**TOWN OF WINCHESTER  
PLANNING BOARD MEETING  
TUESDAY, OCTOBER 13, 2020 @ 7:00PM  
7:00PM CONTINUED PUBLIC HEARING:  
FALL TOWN MEETING ARTICLES  
7:30PM PUBLIC HEARING: 10-16 MT. VERNON STREET  
8:30PM CONTINUED PUBLIC HEARING:  
LORING CT. SUBDIVISION  
9:00PM CONTINUED PUBLIC HEARING:  
654 MAIN STREET  
REMOTE PARTICIPATION**

### October 13, 2020 Planning Board Meeting

**10-16 MT VERNON ST**

Not Approved for Construction  
**Grading and Drainage Plan**

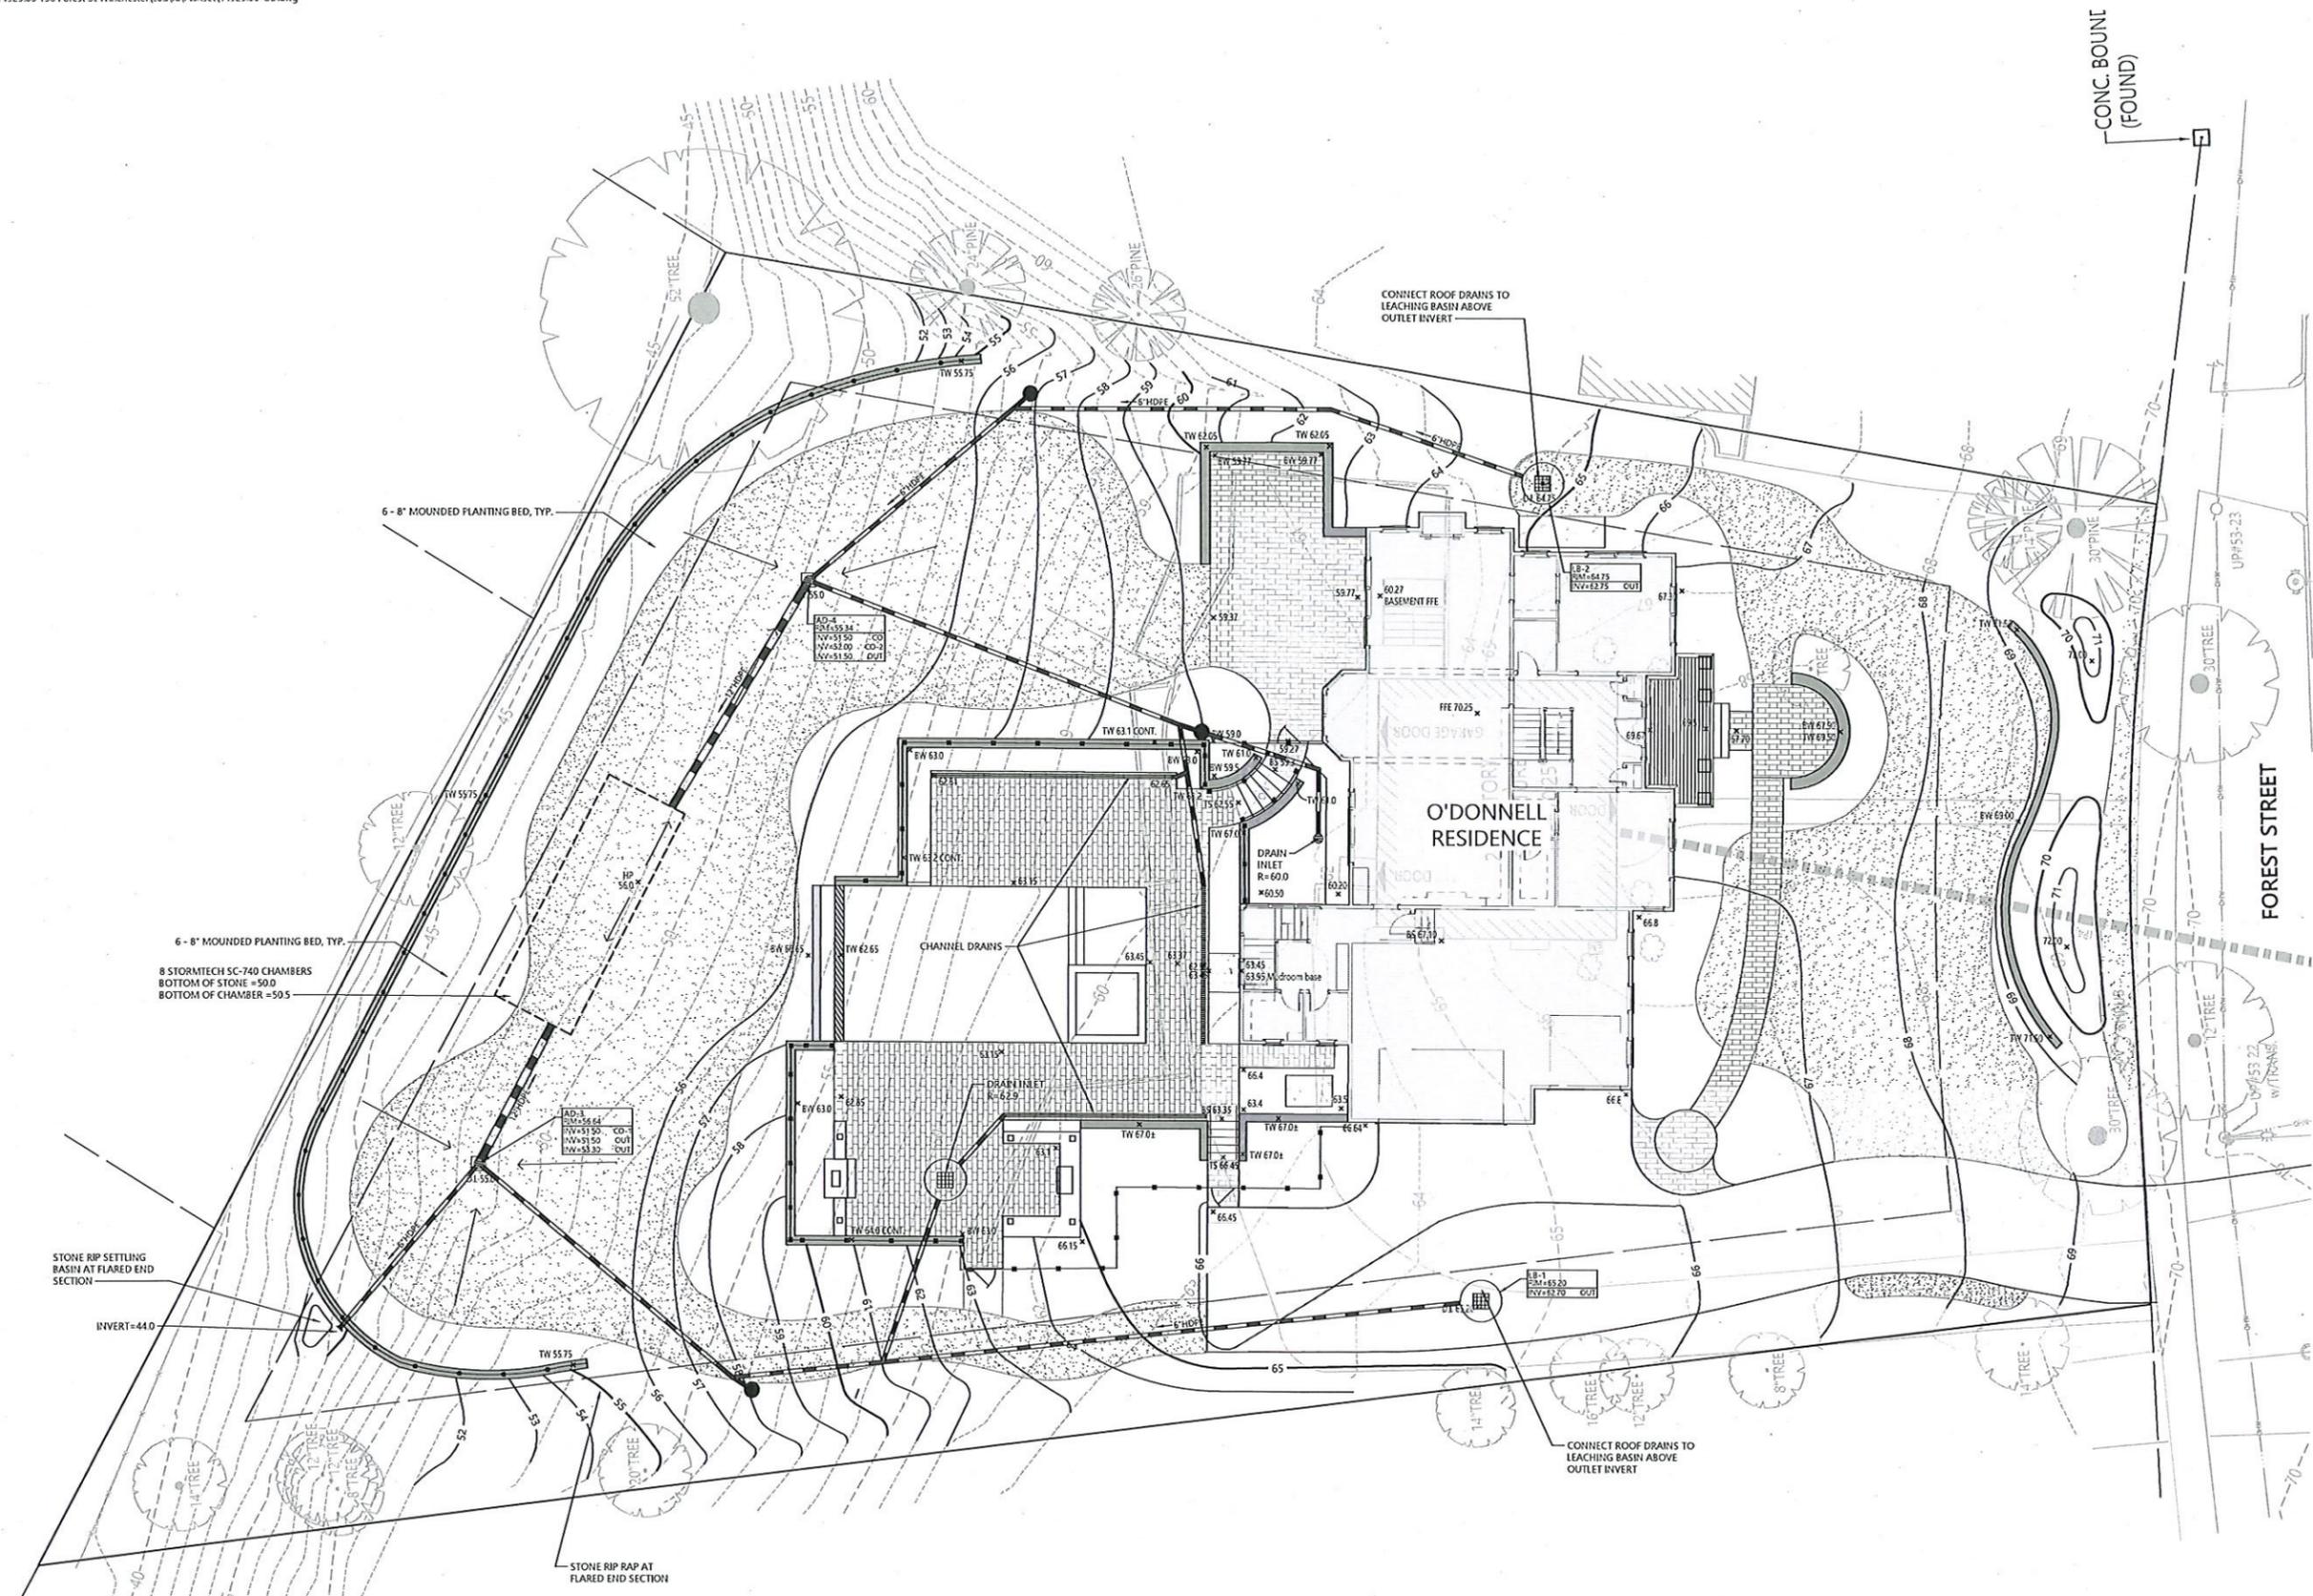
- (2) The drainage calculations show that the roof runoff from the rear of the house will be directed to the infiltration system; however, there is no information on the plans indicating where the roof leaders will be tied in, as with LB-1 and 2. Additional information should be provided.
- (3) The bottom elevation of the leaching catch basin should be added to the plans.
- (4) A clean-out or other structure should be added at the bend in the drain pipe running along the east side of the property from LB-2.
- (5) The connection from the catchbasin in the patio at the rear of the house to the drain pipe coming from LB-1 should be made at a manhole. Also, is this a regular or leaching catchbasin? No information is provided in the plans, and the plans only include details for leaching catchbasins.

- 
- (6) The Engineering Department recommends that all drainage pipes on the property be a minimum of 12-inches in diameter. The plan currently calls for most pipes to be 6-inches.

- (7) The plans show the bottom of the infiltration system to be located at elevation 50', which is approximately 5-feet above the bottom of the retaining wall at the rear of the property that extends from elevation 45 to 55'. The Engineering Department is concerned that water will break-out through the wall before infiltrating. The applicant should evaluate ways to prevent such break-out conditions.

- (8) The Engineering Department is concerned with the outlet design for the infiltration system at the rear of the property. The drain pipe running along the western edge of the property appears to split at AD-3 with water being directed first to the infiltration system through a 12-inch pipe, and second to an outfall through a 6-inch pipe. Although no inverts are given where the 12-inch pipe enters the infiltration system, the plan shows that the pipe slopes in that direction. The HydroCAD calculations show the infiltration system with a 6-inch outlet at elevation 53.3', however, in order to get to that outlet, the flow would have to back up the 12-inch adverse slope pipe. The Engineering Department recommends reconfiguring the drainage on the western side of the property so that it connects directly into the infiltration system, with a separate outlet pipe directed away from the infiltration system.

- (9) The Engineering Department is concerned with possible downstream impacts from the proposed 6-inch outfall on the western edge of the property. We recommend that the applicant install a level spreader in this area to dissipate any flows and reduce the chance of downstream erosion. A detail should be provided.
